PRELIMINARY SAFETY AND ENVIRONMENTAL INFORMATION DOCUMENT

VOLUME I

LIGHT-WATER REACTORS

January 1980

Figure B-1. Decay heat generation vs. cooling time per assembly.

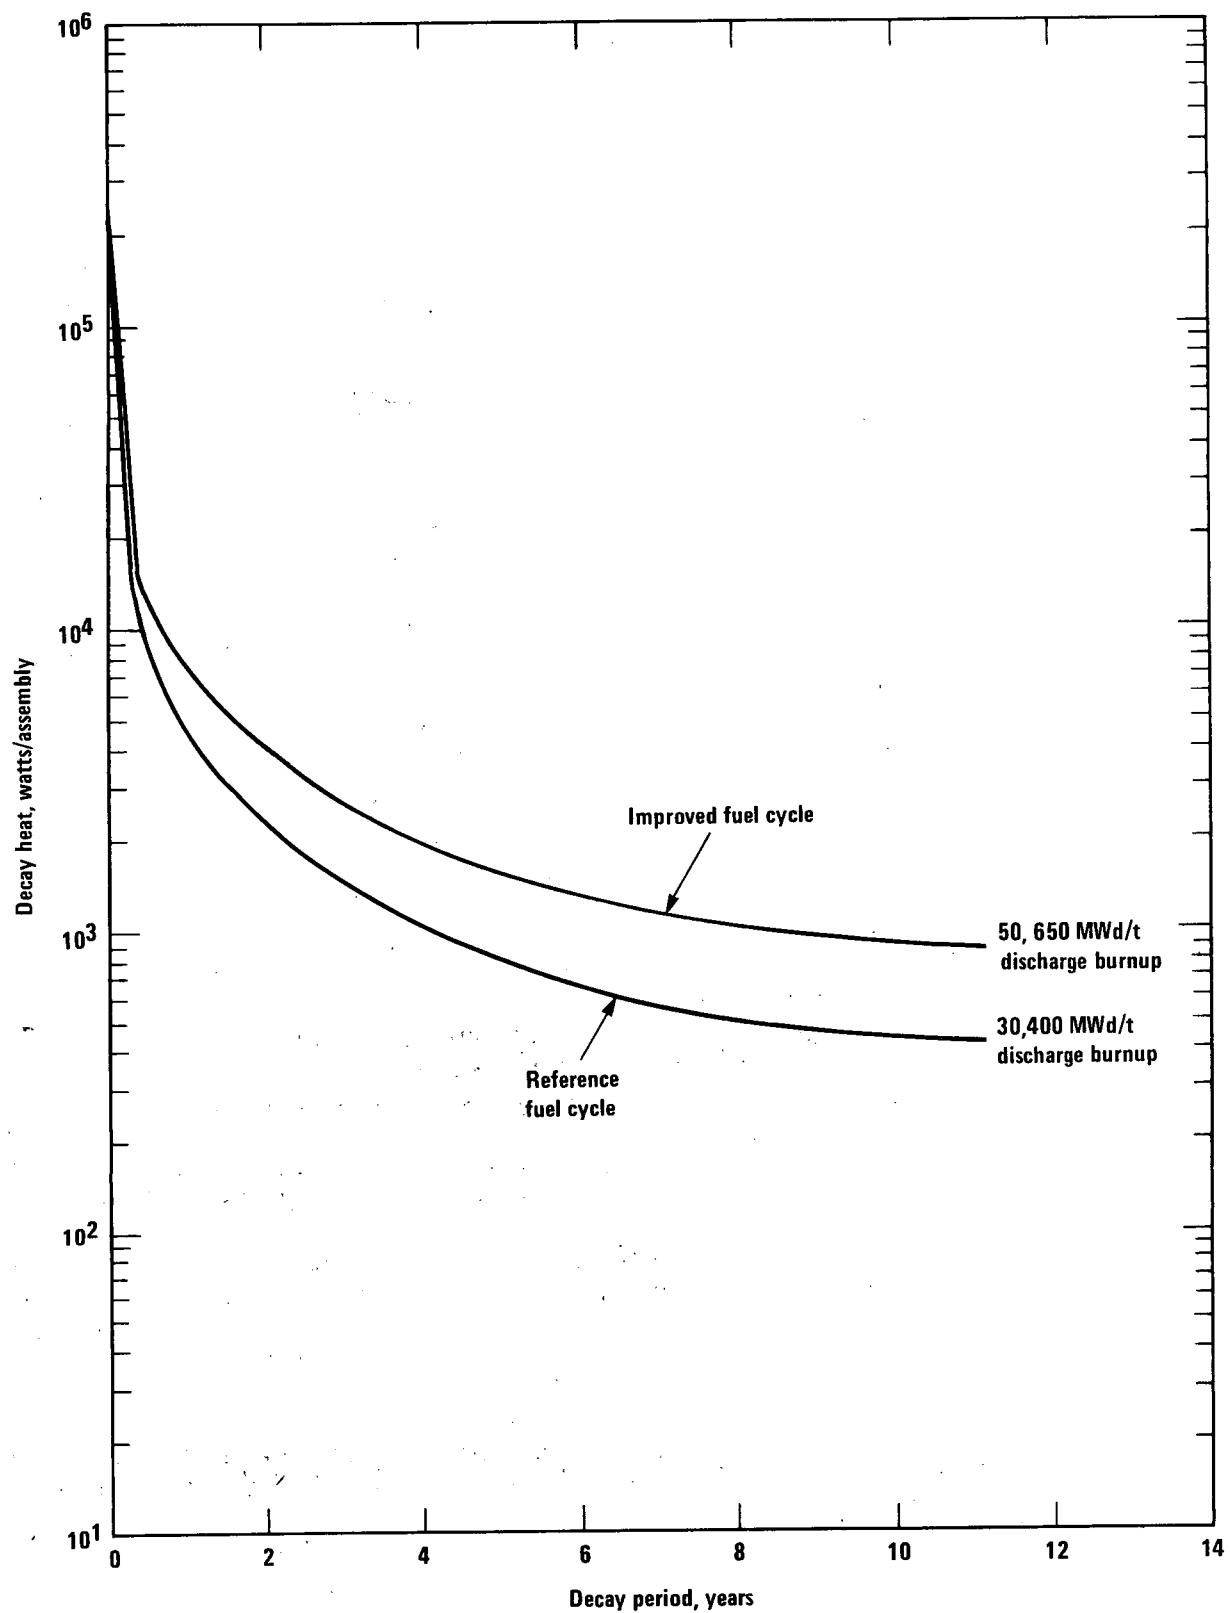
Figure B-1 shows the decay heat from both the 30,000- and 50,000-MWd/MT cycles as a function of time. These curves show that in the long term (e.g., at 10 years), the decay heat of the extended burnup cycle is about twice that of the conventional burnup cycle. In the short term, the decay heats of the two cycles are comparable since they are set by the saturated fission products.
